PORTFOLIO HOLDER DECISION NOTICE

TOPIC – TRAFFIC REGULATION ORDER – VARIOUS ROADS, MICHELDEVER

Title: PROPOSED WAITING
RESTRICTIONS
MICHELDEVER

Scale: NTS	Date: 13/06/2016
Drawn: RVC	Checked:
DRG. No. 810402/314/001	Status:

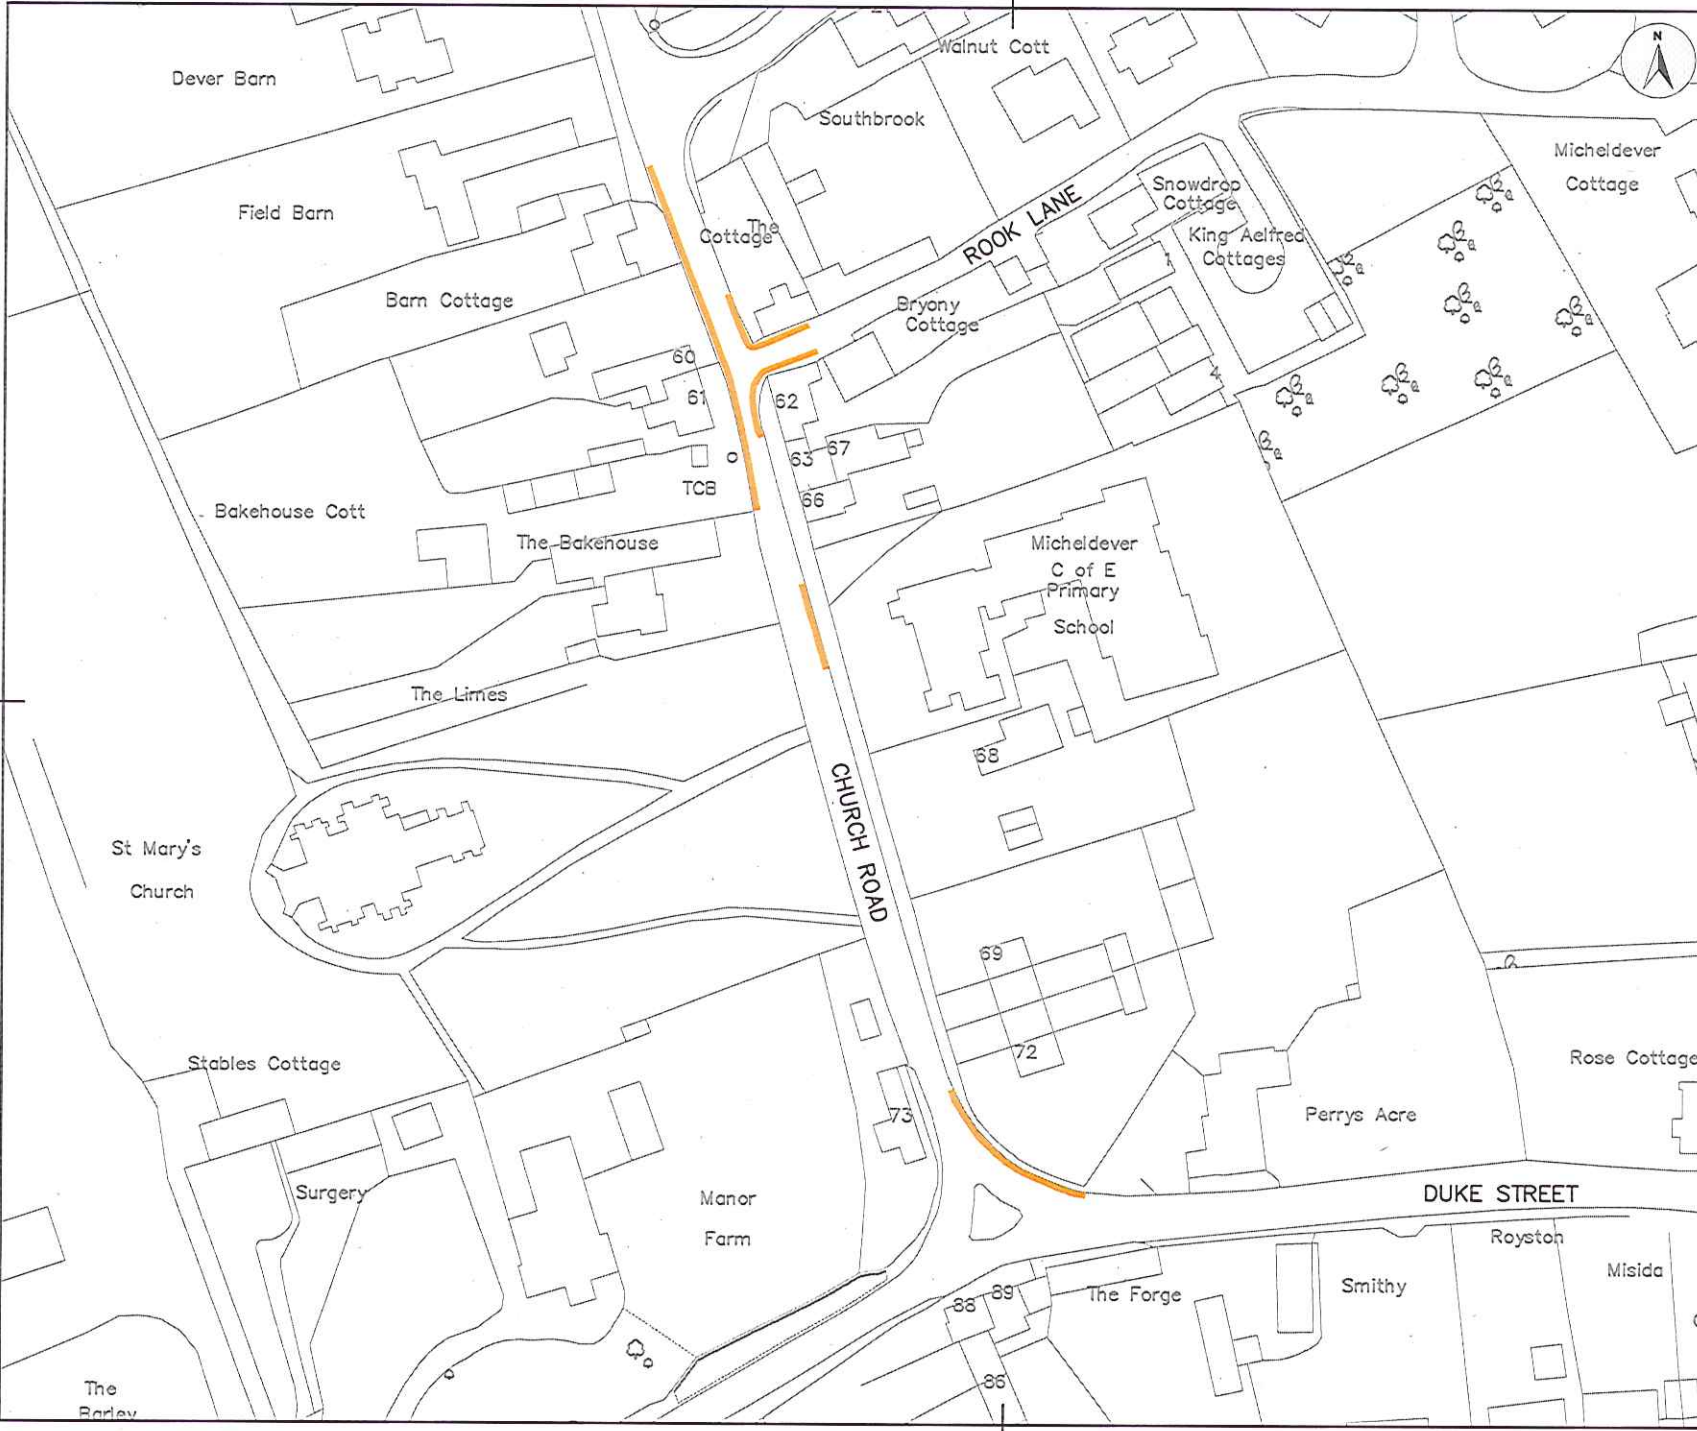
Hello
I'd like to discuss the proposed double-yellow lines on Church Street, please. For many years now (since the school grounds were closed for staff parking) the residents of Church Street have suffered an absolute nightmare for parking by our houses, as the road is treated as the school car park. Removing three more spaces (outside 62, and two by the school gates) by the application of yellow lines will make the situation completely untenable.

I would also point out that the proposed yellow lines by the school gates are presumably some sort of safety measure, but surely only need to be there when the school is being used. During holidays (as I write it's absolute bliss!) and weekends the lines are pointless, and will just restrict parking for us - and people using the church - completely unnecessarily.

So what can be done? One elegant solution is to make Church Street (either the whole thing, or even just the bit north of the school) residents' parking only, and mark it so. This would fix the parking for us in 61, 62, and 63-67. Of course this means that the school staff will have to find somewhere else; but there are at least two solutions for this, too:

I'd like to discuss the proposed double-yellow lines on Church Street, please. For many years now (since the school grounds were closed for staff parking) the residents of Church Street have suffered an absolute nightmare for parking by our houses, as the road is treated as the school car park. Removing three more spaces (outside 62, and two by the school gates) by the application of yellow lines will make the situation completely untenable.

I would also point out that the proposed yellow lines by the school gates are presumably some sort of safety measure, but surely only need to be there when the school is being used. During holidays (as I write it's absolute bliss!) and weekends the lines are pointless, and will just restrict parking for us - and people using the church - completely unnecessarily.

So what can be done? One elegant solution is to make Church Street (either the whole thing, or even just the bit north of the school) residents' parking only, and mark it so. This would fix the parking for us in 61, 62, and 63-67. Of course this means that the school staff will have to find somewhere else; but there are at least two solutions for this, too:

The extent of the proposed double yellow lines has been kept to the absolute minimum to ensure clear access to Rook Lane and on the bend in Church Street, basically mirroring where the existing advisory white markings are at present.

The lines at the entrance to the school are there to protect the entrance to the school if emergency access is required, but they will also enable the school bus to use this area to drop-off and collect pupils as this is allowed on a double yellow line.

1. The use of School Keep Clear zig-zag markings, but this applies to all vehicles and the school bus would therefore need to stop elsewhere.
2. The use of single yellow lines, however these are not as readily observed by motorists and it is more likely that the area would be parked on and the school bus would again find it hard to park.

It is acknowledged that restrictions are not required outside of school term times, but equally outside of these times there is not the same pressure on parking locally, so the proposed restrictions will not realistically reduce the available on-street parking.

Introducing residents permit parking is not a realistic option. There would have to be significant support locally for such restrictions before they would be investigated. They would require more lines and signs. If bays were installed they are very unlikely to be respected by non-residents as they would rarely, if ever, be enforced.

Although it is possible to install single yellow lines with timed restrictions to reflect the school operating times, this would require the erection of adjacent signing with the full details of the times and dates when the restrictions are in force. This would add an unacceptable level of street clutter that would be totally out of place. This reduced visual impact and the better 'self-enforcing' aspect is why double yellow lines were chosen over the more flexible single yellow line option.
